ALERT SERVICE BULLETIN

429-17-36  
6 March 2017

**SUBJECT:** CONDENSER FAN MOTOR MOUNT FASTENER,  
INSPECTION OF.

**Title:** SB 429-201-1 Bell 429 Condenser Fan Motor Mount Fastener Inspection

**Figure 1**

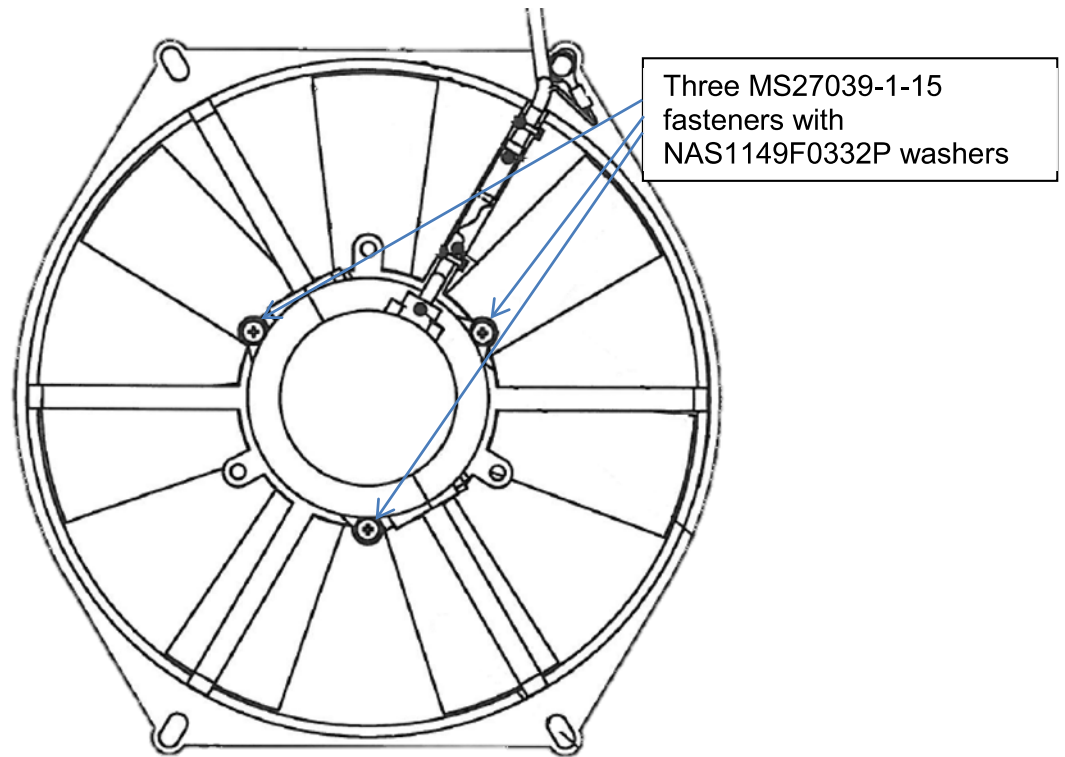
During an annual inspection, an operator reported finding the condenser fan motor detached from the condenser blower assembly and resting on the collective control tube. The condenser fan motor is secured to the condenser blower assembly by 3 fasteners with thread locker applied. Evidence suggests that some motor mount fasteners may have had misapplied thread locker.

1. Locate and visually inspect the condenser fan motor securement. Refer to Figure 1 to identify the three MS27039-1-15 fasteners mounting the condenser motor to the condenser blower assembly.

- e) Make log entry that the air-conditioning system is DEACTIVATED per ACC service bulletin SB 429-201-1.
4. Replace missing fasteners and remove and reinstall existing fasteners as follows:

- a. Clean the threads of the fastener of any debris and/or existing thread locker residue.
  - b. If no thread locker is found on existing fasteners, report incident to ACC at: Phone 303-440-4075, Fax 303-440-6355, or E-mail [service@aircommcorp.com](mailto:service@aircommcorp.com)

- c. Apply Loctite 222 to the fastener threads and re-install fastener with 20 to 25 in-lbf torque.
  - d. Once all fasteners are secure, apply torque stripe to the head of each fastener.

- e. Allow a minimum of 6 hours for Loctite to cure prior to aircraft flight operations.
5. Make log entry that this service bulletin SB 429-201-1 has been performed.
